MEMORANDUM

FILE NO.: CSP2011-0008

PROPOSAL: A City project review for the reconstruction of Berners Avenue in the southern Mendenhall Valley area.

BERNERS AVENUE RECONSTRUCTION CONTRACT NO. E12-117

Figure 3: Proposed Road Profile

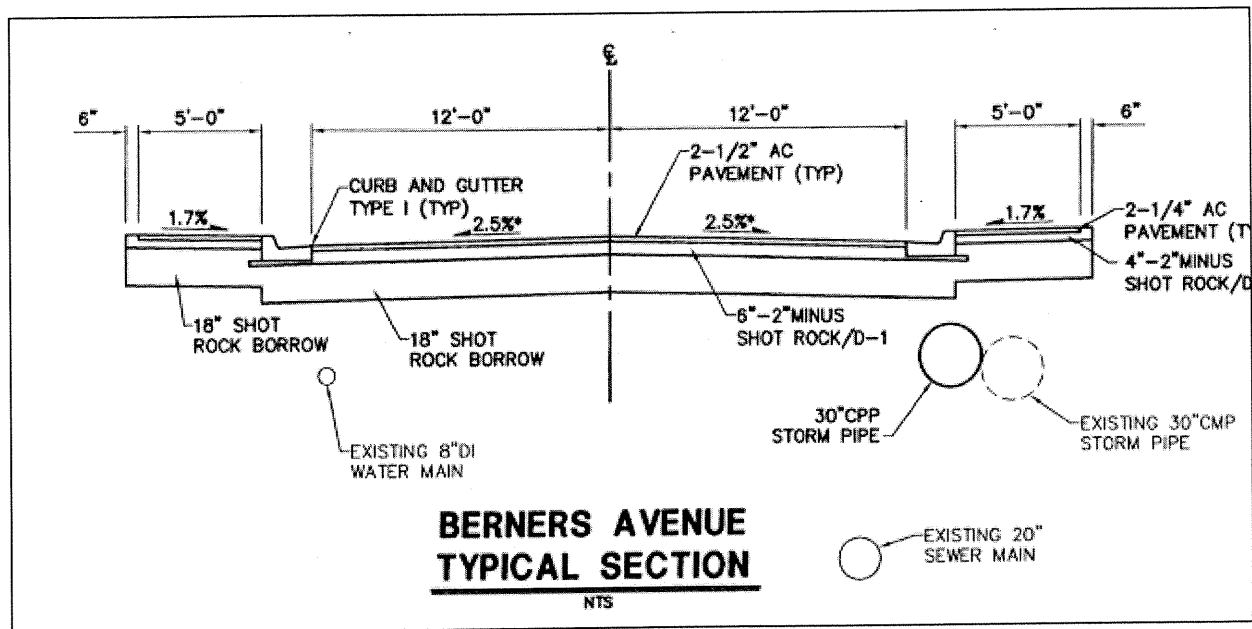
Many of these items are incorporated into the project. The applicant indicates that there is insufficient room for bicycle lanes with 2, 5-foot wide sidewalks. Bicyclists can safely share the road with automobiles by using the road shoulder or travel lane. The recommended lane width of 11 feet is 1 foot less than what it proposed. An 11-foot travel lane is stated in the Plan as a traffic calming element.

staff finds that an 11-foot travel lane would make the project more consistent with the NMTP.
